Access Compliance Report

Public Rights-of-Way (Curb Ramps)

Intersection ID: 24539	Main Street: WALKERS_CREEK_DR	Cross Street: N/A	Location: SE
ADA ID: E73836E01F47	Ramp Type: Directional1	Initial Pass/Fail: Fail	Overall Compliance: No
Codes/Mitigation Info/Possible Solution		Field Measurements/Component Compliance	
Severity Score: 21.25

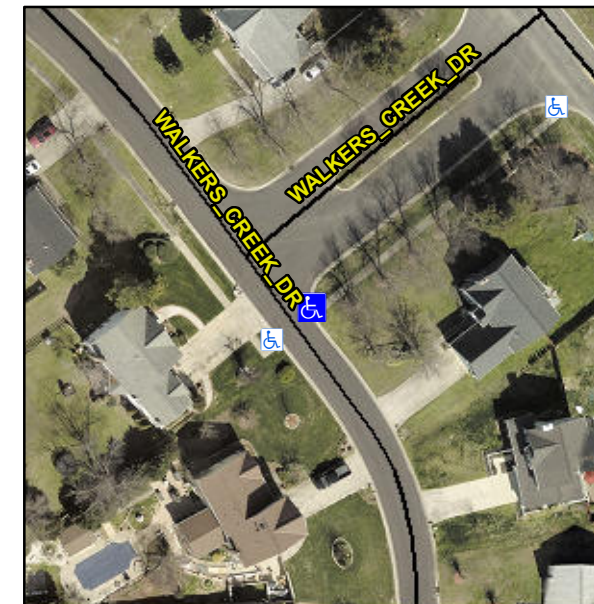
R304.5.1, R304.5.3

Compliance	Description	Data	Compliance	Description	Data
N/A	Ramp Length (in)	34.0	N/A	Grade Break?	N/A
No	Ramp Width (in)	47.5	N/A	Grade Break Slope (%)	0.0
Yes	Ramp Slope (%)	7.8	N/A	Grade Break XSlope (%)	0.0
No	Ramp XSlope (%)	6.5			
N/A	Flare Type LT	N/A	N/A	Flare Type RT	N/A
N/A	Flare Slope LT (%)	N/A	N/A	Flare Slope RT (%)	0.0
N/A	Flare Traversable LT?	N/A	N/A	Flare Traversable RT?	N/A
N/A	Landing Length (in)	0.0	N/A	DWS Provided?	N/A
N/A	Landing Width (in)	0.0	N/A	DWS Contrast?	N/A
N/A	Landing Slope (%)	0.0	N/A	DWS Length (in)	N/A
N/A	Landing X Slope (%)	0.0	N/A	DWS Full Width?	N/A
N/A	Landing Curb? (Y/N)	N/A	N/A	DWS Offset LT (in)	N/A
N/A	Shared Landing?	N/A	N/A	DWS Offset RT (in)	N/A
N/A	Gutter Ponding?	0.0	N/A	Gutter Slope (%)	N/A
N/A	Gutter Lip Ht (in)	0.0	N/A	Gutter X Slope (%)	N/A
N/A	Painted X Walk1?	No		Road Slope (%)	1.2
	X Walk 1 Direction	To SW		Road X Slope (%)	2.1
	X Walk 1 Width (in)	N/A		Clear Space?	N/A

X Walk 1 Slope (%)	1.2	N/A	Clear Space to XWalk (in)	N/A
	X Walk 1 X Slope (%)	2.1	N/A	Storm Grate/Utility Hazard?	N/A
N/A	Ramp inside XWalk1?	N/A		Storm Grate/Utility Type	
N/A	Any Obstructions?	N/A			N/A
	Obstruction Type		Yes	Surface Condition? (G/P)	Good
			N/A	Curb Slope (%)	8.4

Remove & Replace Entire Ramp.
